ORIGINATION FORM

Proposed Revisions to a Standard Plans Index
(Please provide all information – Incomplete forms will be returned)

Index Number: 521-660
Sheet Number (s): 1, 3 & 4
Index Title: Light Pole Pedestal - Bridge

Summary of the changes:

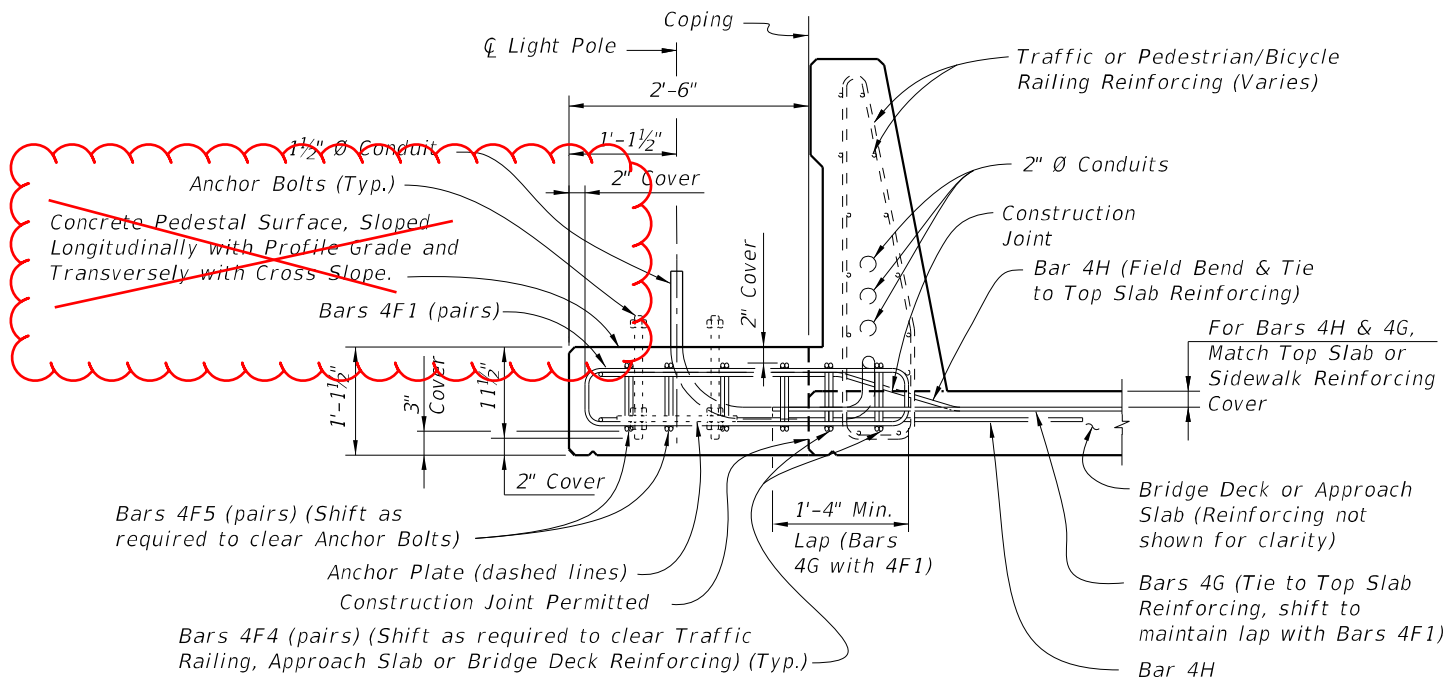
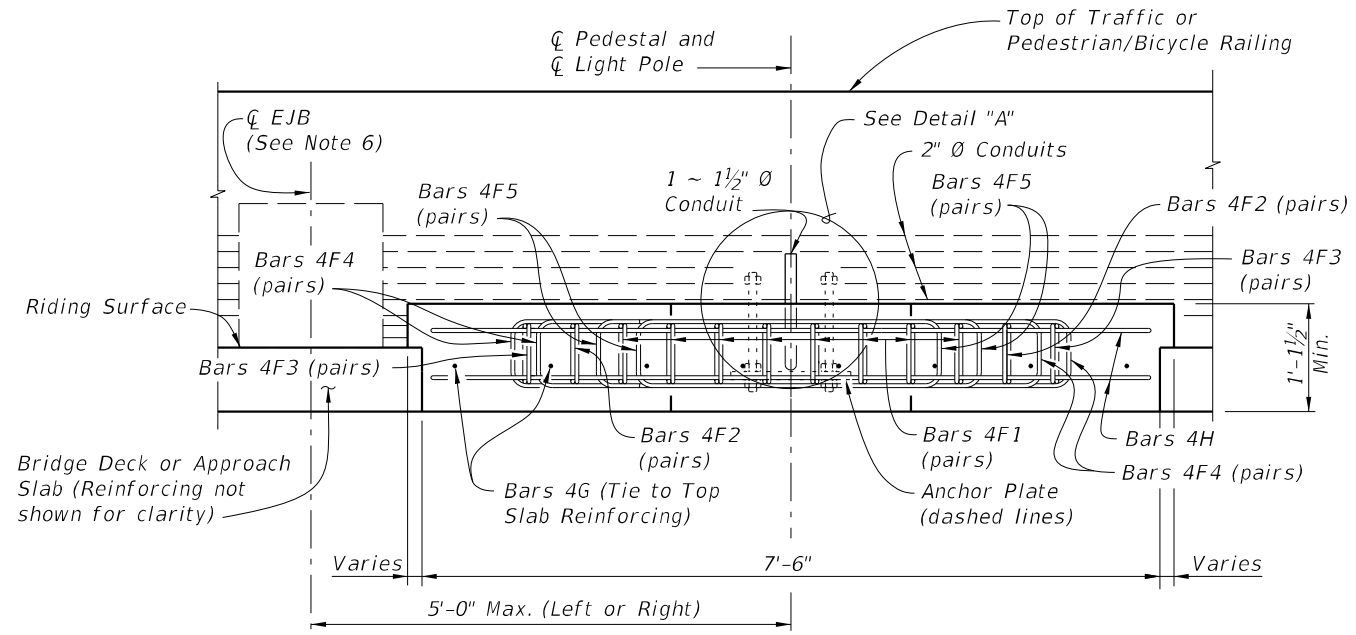
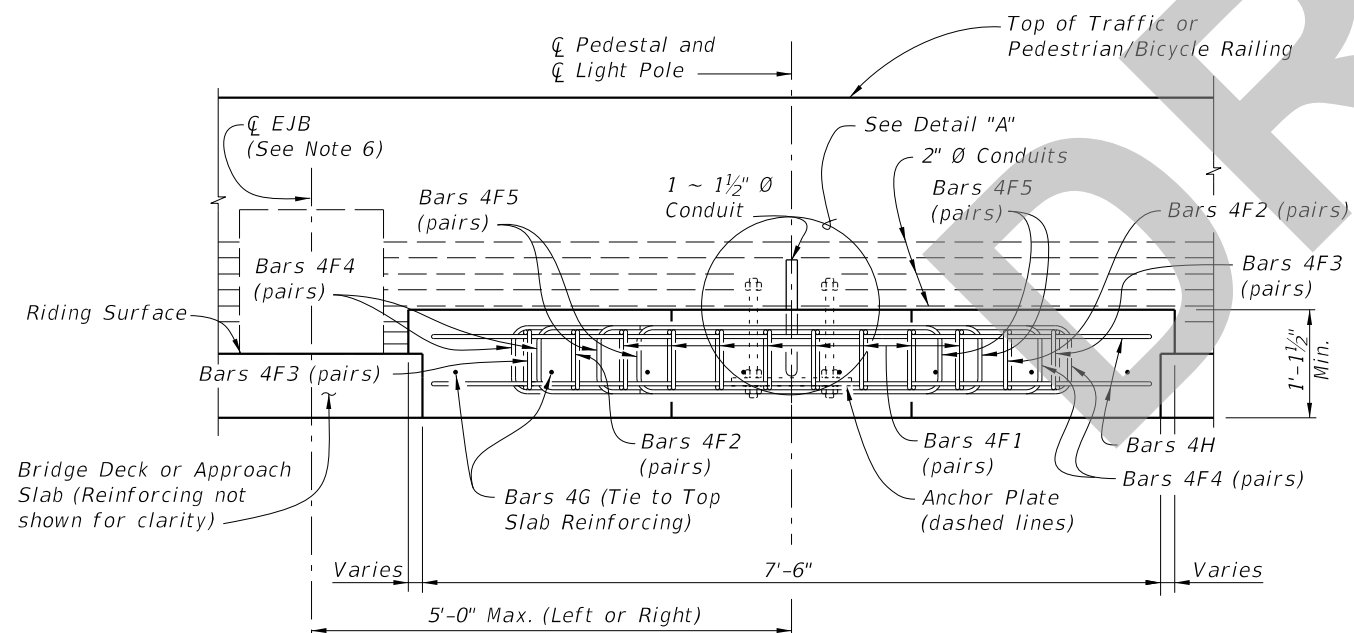
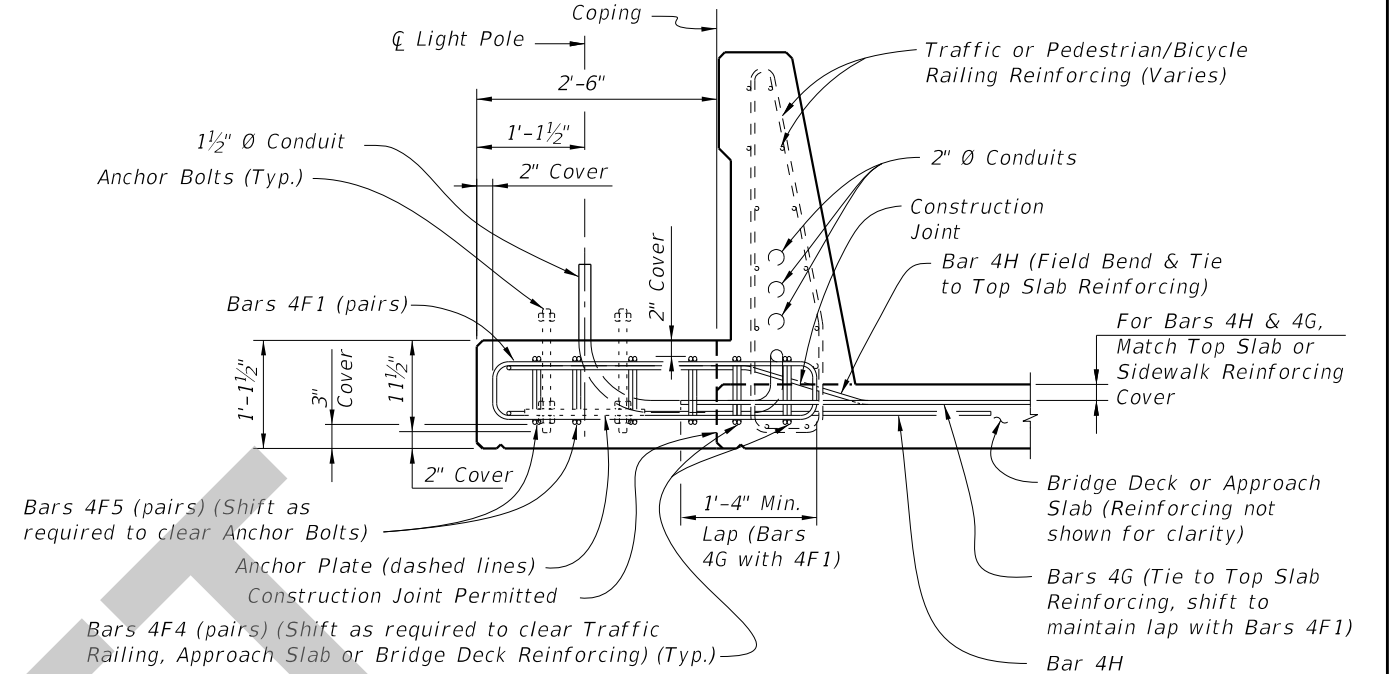
Deleted notes on sloping top surface of concrete Pedestals
